Service Letter: 426 (page 1 of 2)

Title: Inspection / Upgrade of Wing Tip Navigational Light Wires

Models: All Bellanca/American Champion model 7's and 8's built before August 1996 that have strobe and navigation wires running to the wing tip.

**Figure 1, View of Wire and Standoff on Compression Tube**

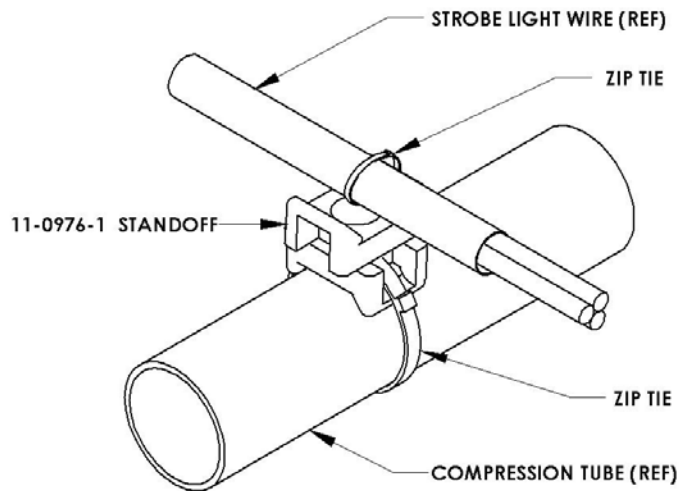
Description: Previous to August 1996, all aircraft with wing tip lights routed the wires down the center of drag truss of the wing. The wires were attached to the compression tubes with adhesive fabric tape. With time, this tape becomes brittle and can fail, allowing the wire to wear against the compression tube. There have been numerous reports of the wire chaffing through its insulation and grounding, blowing the fuse or popping the breaker.

Procedure: Using the inspection holes that are placed at the compression tube stations, inspect the wires where they are taped to the center of each compression tube. Check to ensure that the fabric tape holding the wires to the compression tube securely retains the wires.

If the wires are not securely attached, the tape should carefully be removed from the tube and wire. Upon removing the tape, inspect the wires for any signs of chaffing through the insulation. If chaffing has occurred replace the wire.

To preclude wire chaffing, wire standoff should be installed to separate the strobe and navigation wires from the compression tubes. Install ACA P/N 11-0976-1, or equivalent, wire standoff directly on top of each compression member where the wire crosses using one zip tie (P/N: PLT 2S-MD or equivalent) around the compression member as seen in Figure 1. The standoff should be rotated 90 degrees to allow it to seat on the compression tube and allow the wires to be zip tied to the standoff. Zip tie (P/N: VUVT 06M M or equivalent) the wires to one side of the standoff (see Figure 1) tight enough to prevent slip between the wires and zip tie. Leave some wire slack between each standoff.
